GEORGETOWN-SCOTT COUNTY PLANNING COMMISSION

**AGENDA
JUNE 13, 2024
6:00 p.m.**

**GOLF TOWNHOMES OF CHERRY BLOSSOM PHASE 7
PRELIMINARY SUBDIVISION PLAT & DEVELOPMENT PLAN**

**Staff Report to the Georgetown-Scott County Planning Commission
June 13, 2024
(postponed from 05/09/2024)**

C.7
LANDSCAPING
PLAN

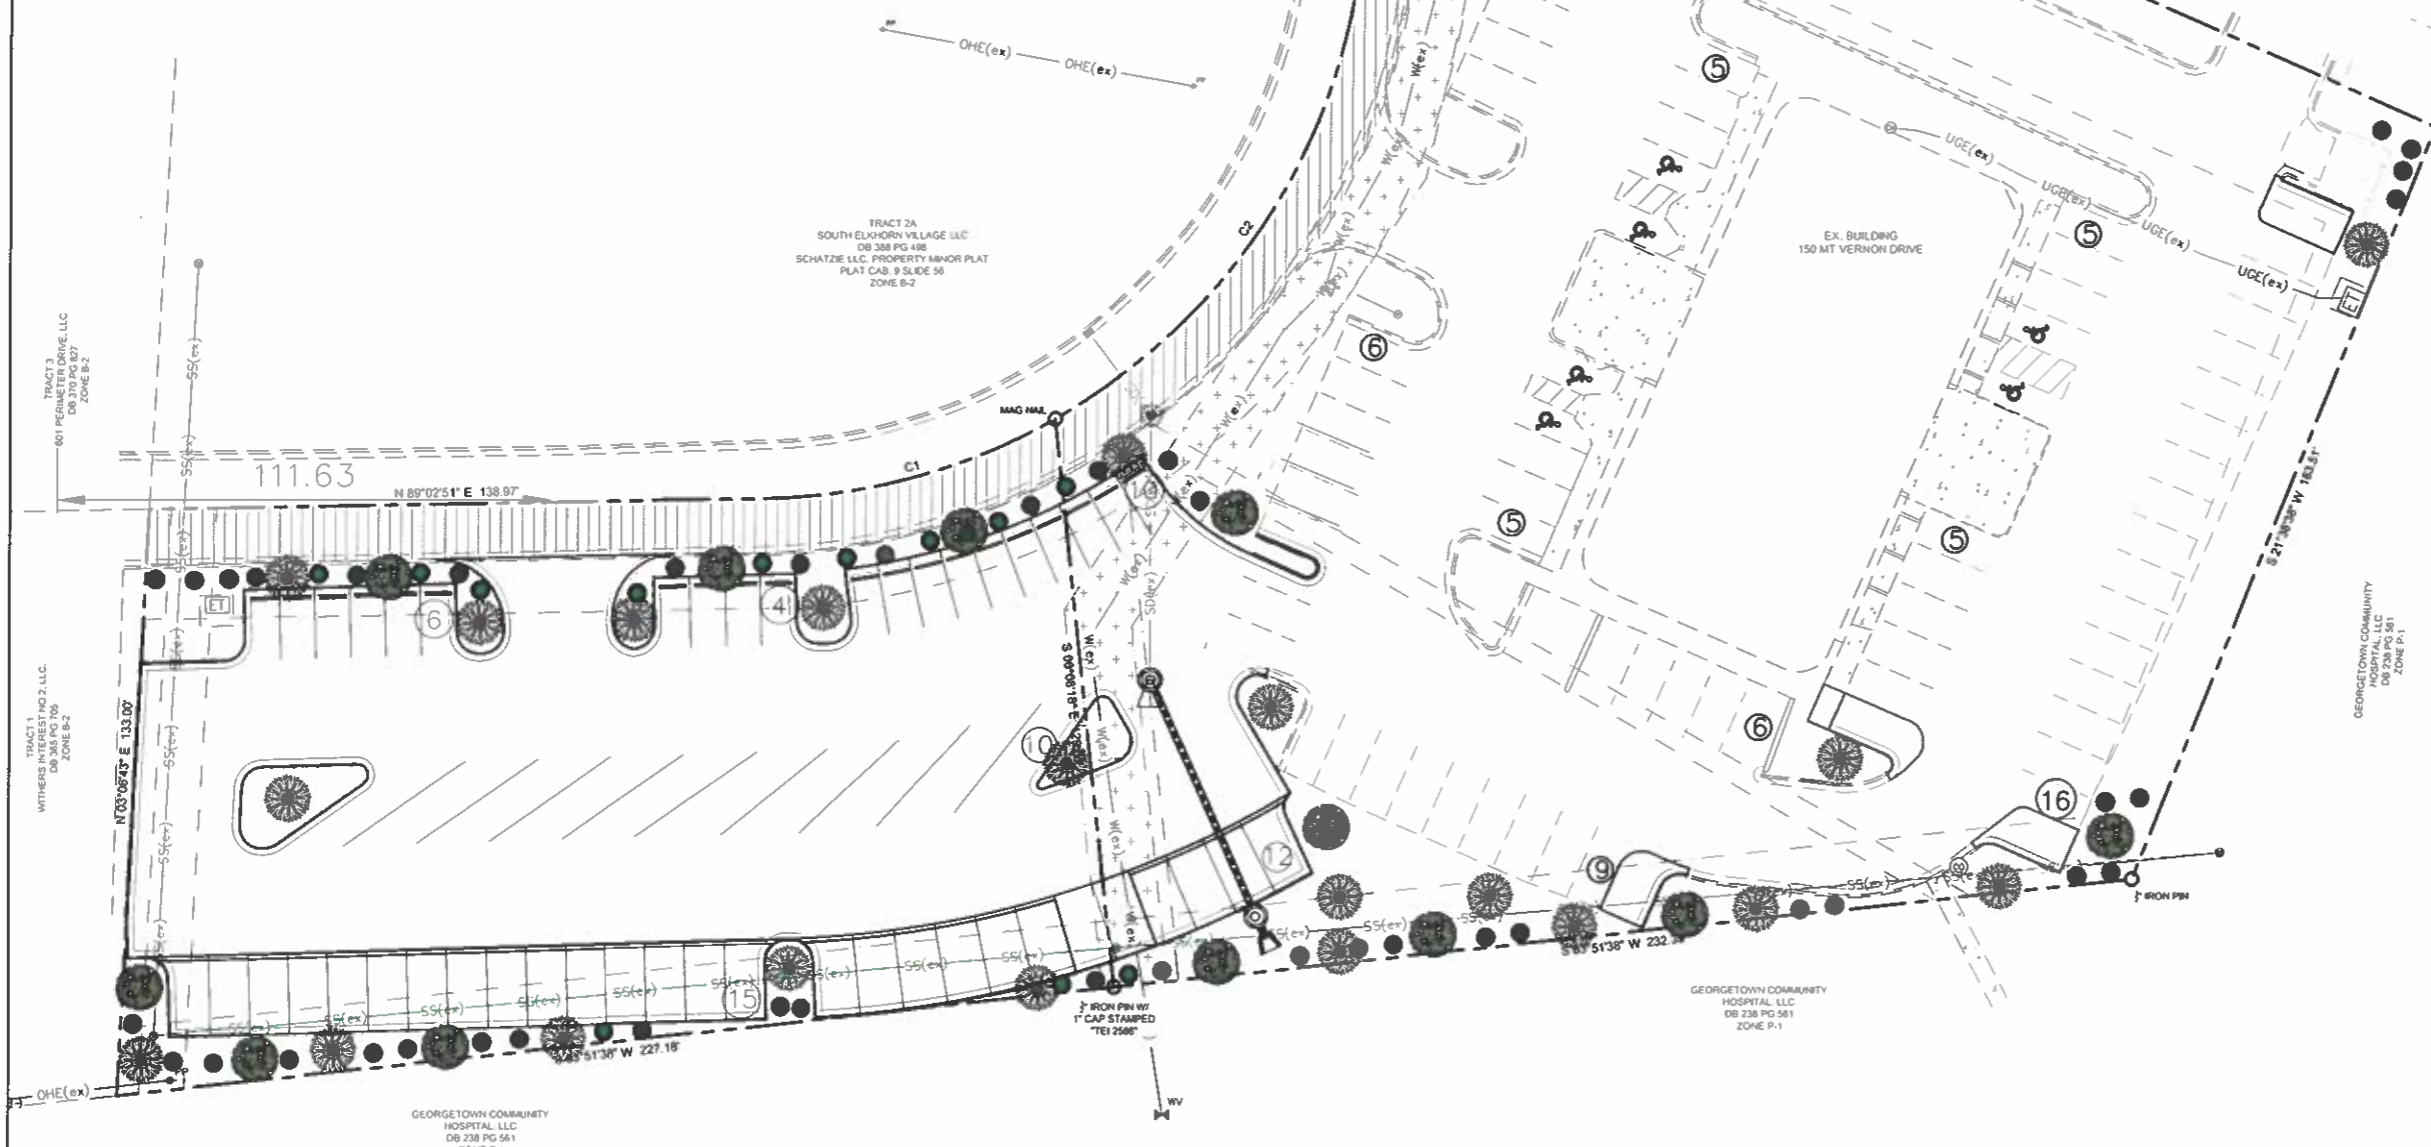
Any vehicular use area (VUA) on any property adjoining any property in any zone, except industrial or agricultural shall provide a minimum landscape buffer of: 5' to edge of pavement, where vehicles overhang; 4' minimum from edge of paving; and 3' (that prohibits any vehicular overhang) for other areas, on boundary of portion of vehicular use area that faces adjacent property. This buffer shall contain: 1 tree per 40' of boundary of vehicular use area, plus, a 3' average height continuous planting, hedge, fence, wall, or earth mound; or a 3' decrease in elevation from the adjoining property to the vehicular use area.

The Landscape Plan does show appropriate spacing, height and species for both trees and shrubs to create effective and compliant perimeter screening.

VUA's greater than 6000 sq. ft. and/or 20 parking spaces must provide interior landscaping. For every 100 sq. ft. of VUA, 10 sq. ft. of interior landscaping must be provided. By this ratio, 5286.70 sq. ft. would be required. The applicant indicates they will provide 6113.83 sq. ft of interior landscaping, exceeding the minimum required.

The current landscape plan proposes 33 new trees (21 "large", and 12 "medium") for a total of 20,500 sq. ft. of canopy coverage, both within the interior of the VUA, and along the perimeter. There will be nine trees (unidentified species) preserved as part of the preexisting VUA landscaping, amounting to 10,670.85 sq.ft. There will be 42 total trees on site, exceeding the minimum requirement of 22 (1 tree per every 250 sq.ft. of landscape area).

This brings the total canopy coverage on site to 31,170.85 sq. ft. This is equivalent to 35.7% of the total site area, well exceeding the required 22% coverage for commercial uses that are retaining a 10-15% site coverage before expansion.

5. The applicant shall be responsible for providing landscaping area and landscaping which meets the minimum requirements of the Landscape and Land Use Buffer Ordinance on the Final Development Plan. A specie-specific landscape plan shall be included with the Final Development Plan.
